CONSTRUCTION SUMMARY

Forestside Estates Inc.

LOT NUMBER	PHASE	HOUSE TYPE	CLOSING DATE	
148 BLOCK 6	6-III	Blue Ash 2A1	01-Jun-23

BUILDING C

Suite: 148

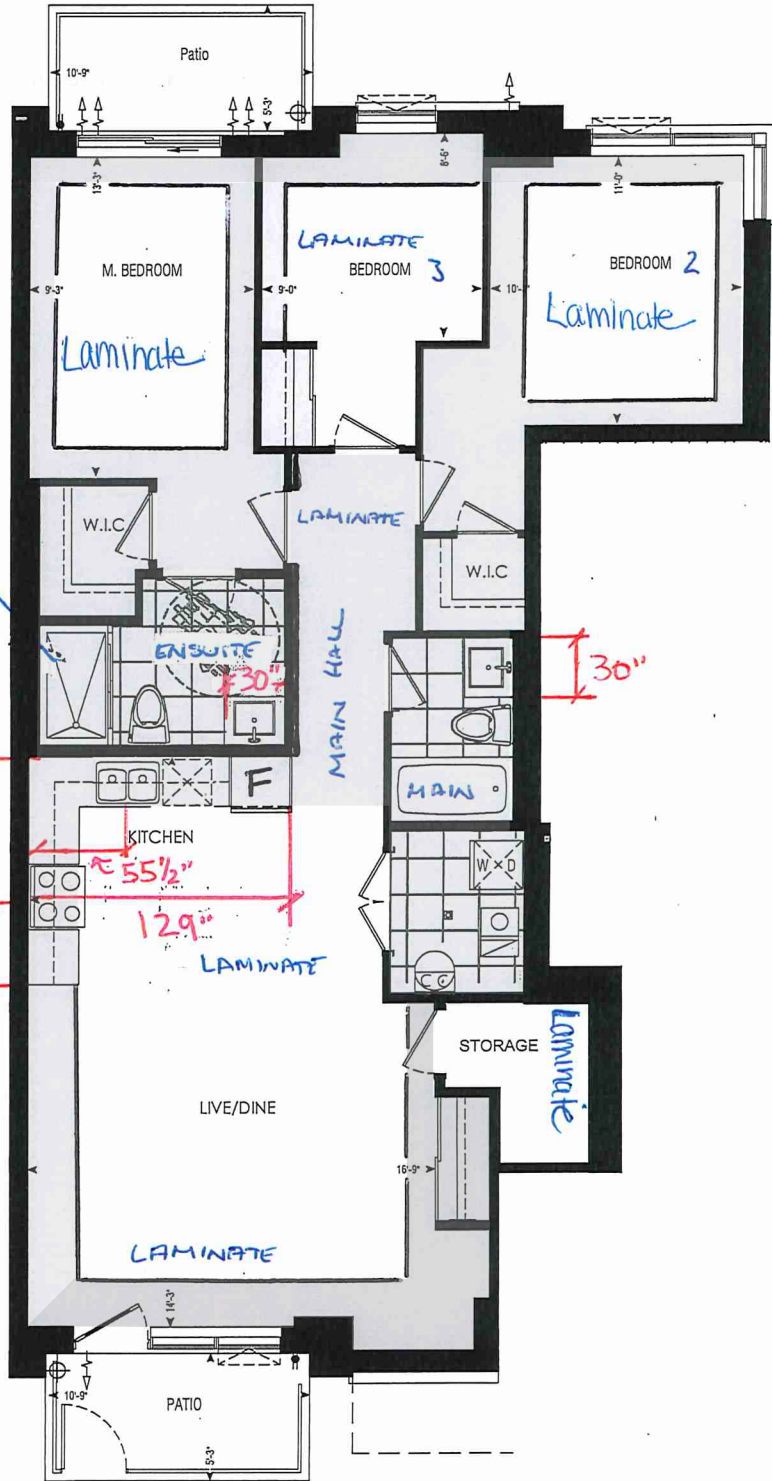
1 - APPLIANCE PACKAGE- Install the Standard Appliance Package. To be installed throughout the suite, where applicable (See Sketch)

1 - KITCHEN & BATHROOMS - Purchaser has DECLINED All Upgrades offered during decor appointment at the decor centre for kitchen & bathroom cabinetry. Standard Kitchen Layout & Standard Bathroom Vanities to be installed as per standard plan. (See Sketch)

132 - MAIN FLOOR - FLOORING - Install UPGRADE 2 FLOOR TILES (20X20 Pulpis Gris) throughout the main floor where applicable in lieu of the builder's standard floor tiles. To include; Laundry/Mechanical Room, Main Bath, & Master Ensuite.

1 - MASTER BEDROOM - FLOORING - Install UPGRADED LAMINATE throughout the master bedroom where applicable in lieu of the builder's standard broadloom. Install 8" HIGHLAND SUTTON OAK EE-H-289 (See sketch)

1 - BEDROOM 2- FLOORING - Install UPGRADED LAMINATE throughout bedroom 2 where applicable in lieu of the builder's standard broadloom.
Install 8" HIGHLAND SUTTON OAK EE-H-289 (See sketch)
Note: To include Shoe mould

1 - BEDROOM 3 - FLOORING - Install UPGRADED LAMINATE throughout bedroom 3 where applicable in lieu of the builder's standard broadloom. Install 8" HIGHLAND SUTTON OAK EE-H-289 (See sketch)
Note: To include shoe mould

SINK WALL ELEVATION

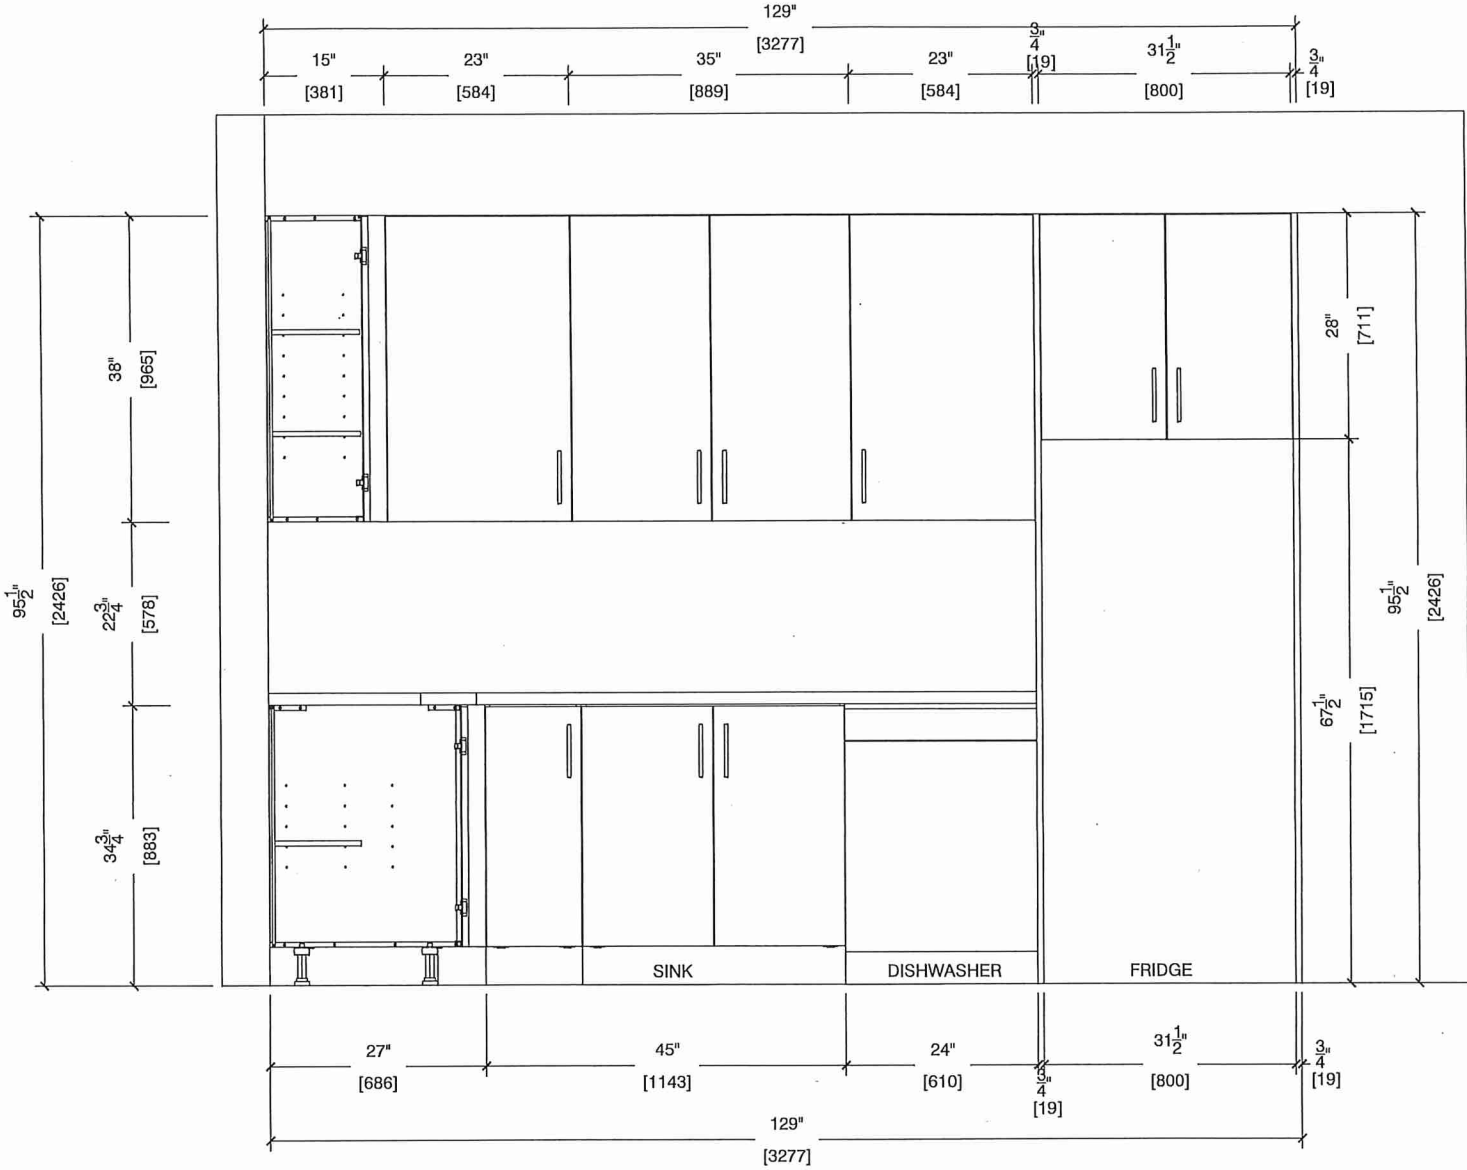
1 - KITCHEN-PLUMBING - Install the builders standard Top mount sink in the kitchen- Install the BLANCO HORIZON 2.0 (7") Top mount Sink- Model # 401124 (see sketch)

45 - KITCHEN - WALL TILES - Install UPGRADE 1 BACKSPLASH throughout the kitchen in lieu of the builder's standard backsplash. To install TWILIGHT PEWTER/SMOKE. Does not include behind stove/fridge (See Sketch)
